# Addendum 02

**PROJECT:** Riverside Local School District  
Central Office and Health Clinic Addition  
2096 County Road 24 S  
De Graff, Ohio 43318

**PROJECT #:** 22071-00

**Type 4.0**

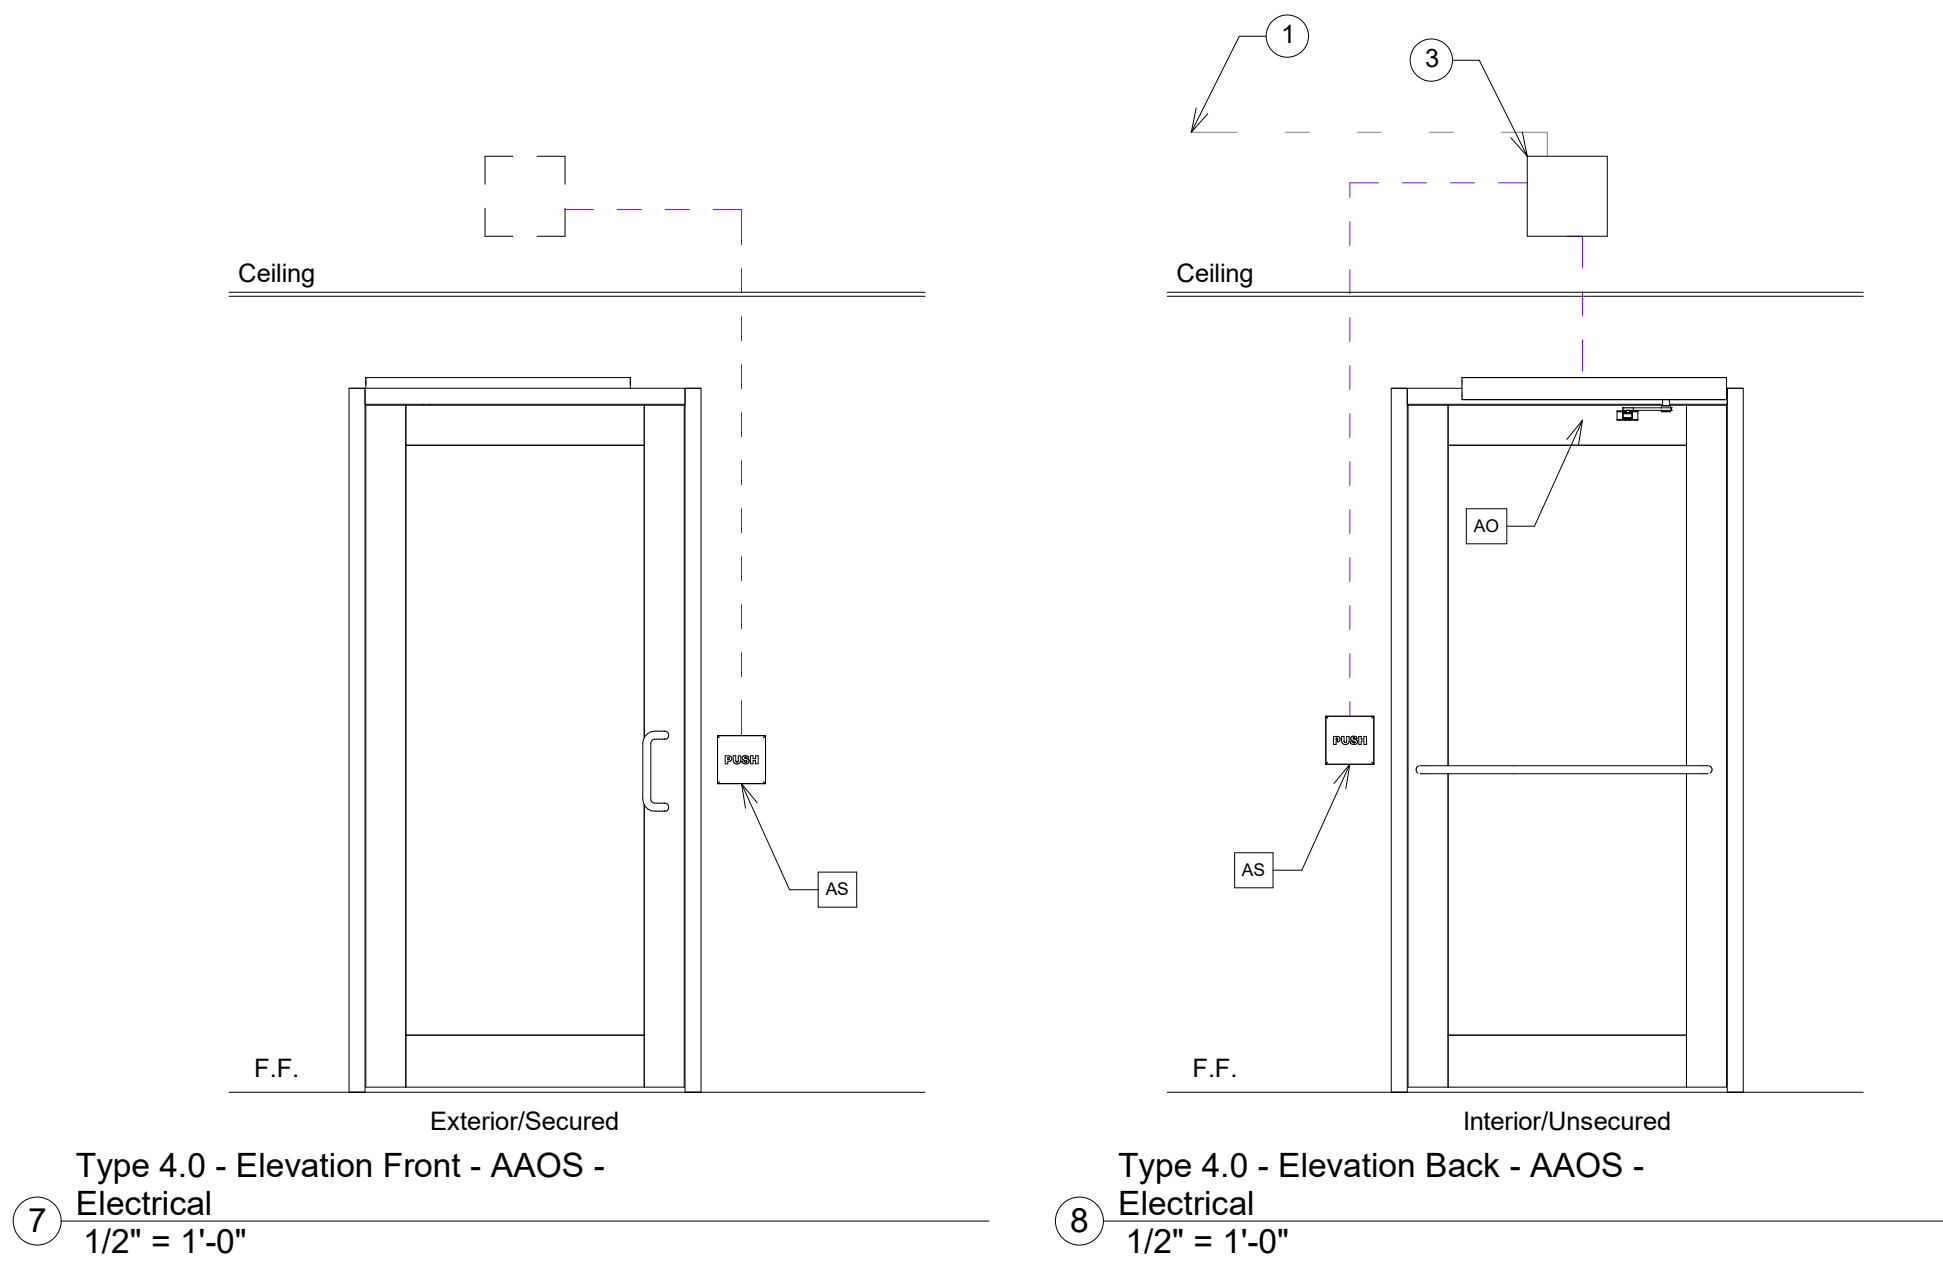
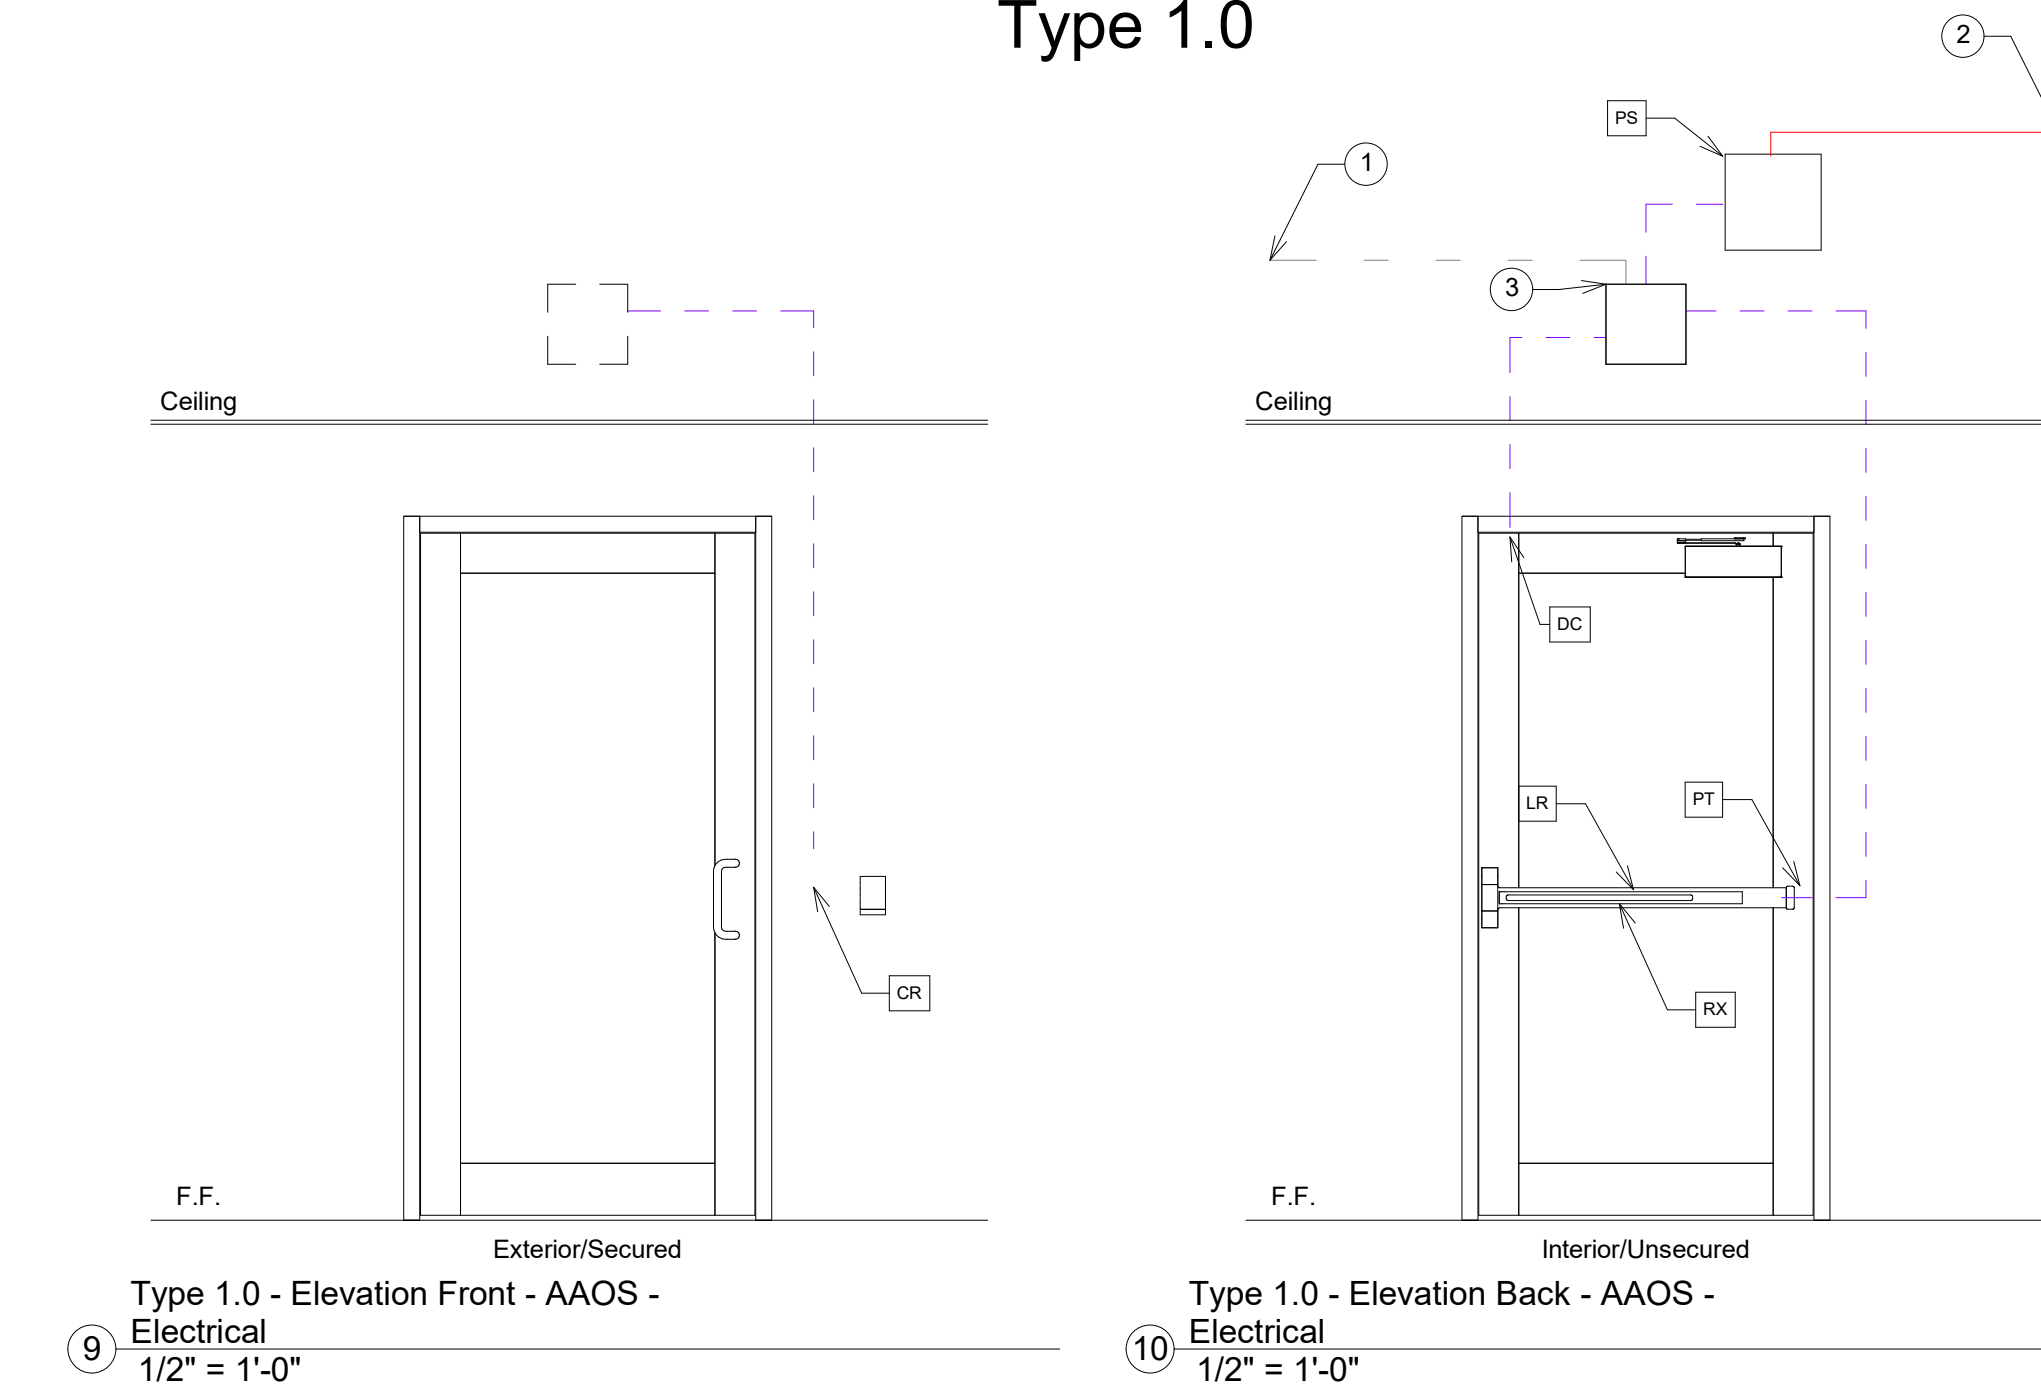
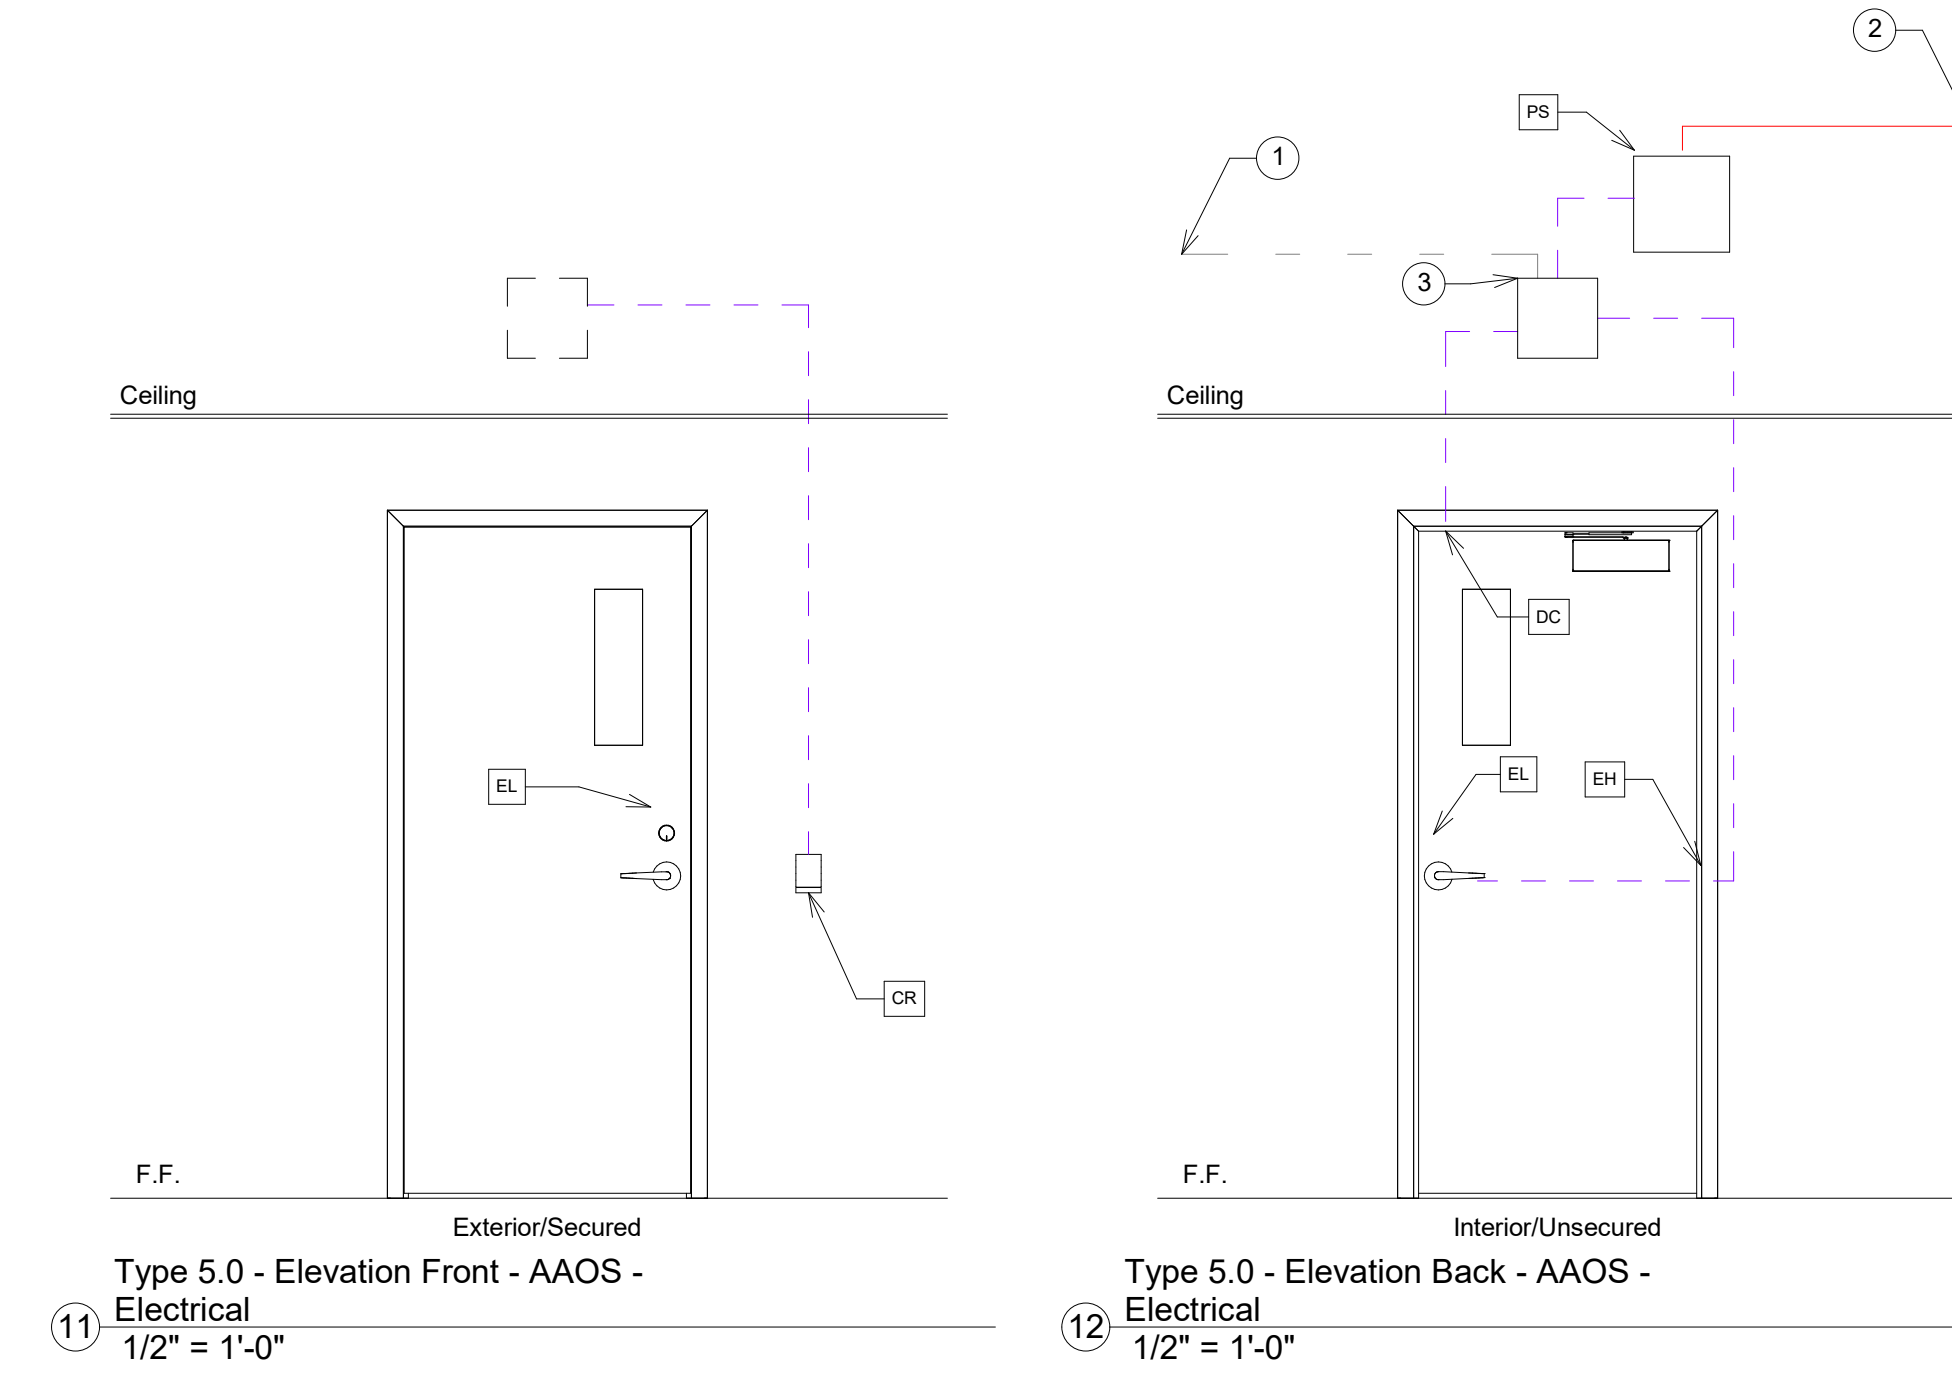
1. Add drawing Sheet E1.3 EAC Security Elevations in its entirety. Reference sheet attached.
2. Add drawing Sheet E1.4 EAC Security Elevations in its entirety. Reference sheet attached.
